**To:** Plan Holders  
**CC:** Town of Kernersville, NC  
**From:** J. Clark Maness, PE  
**Date:** 4/28/2023  
**Project:** Town of Kernersville – Kernersville Medical Parkway Sewer Extension

ADDENDUM 1

**PIPE TRENCH FOR PVC AND DIP**  
NOT TO SCALE  
0309  
2014-14-08

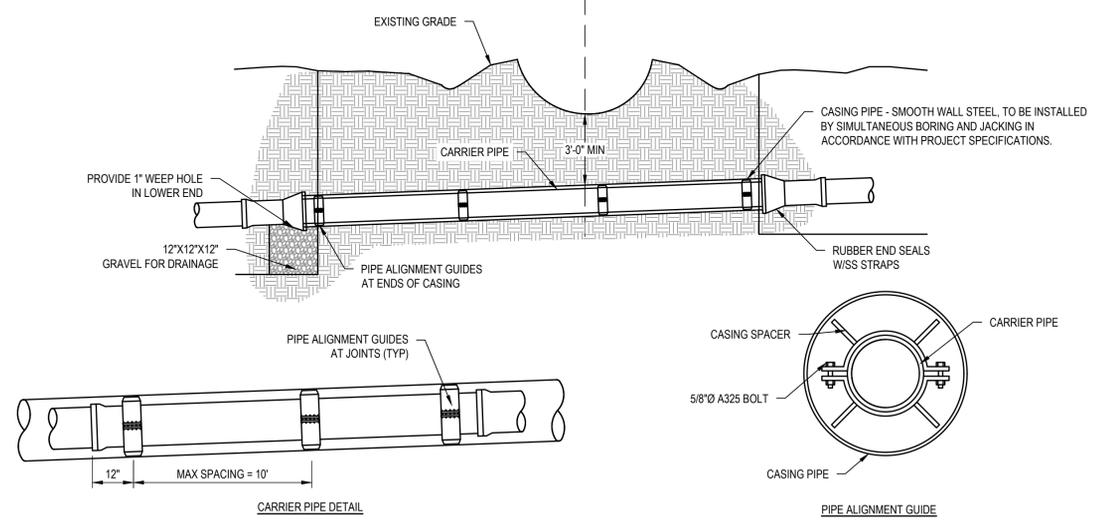
1. Please see the attached updated Sheet 5. The pipe trench detail for ductile iron pipe (DIP) has been updated to include additional bedding and the installation of geotextile fabric for all trenches.
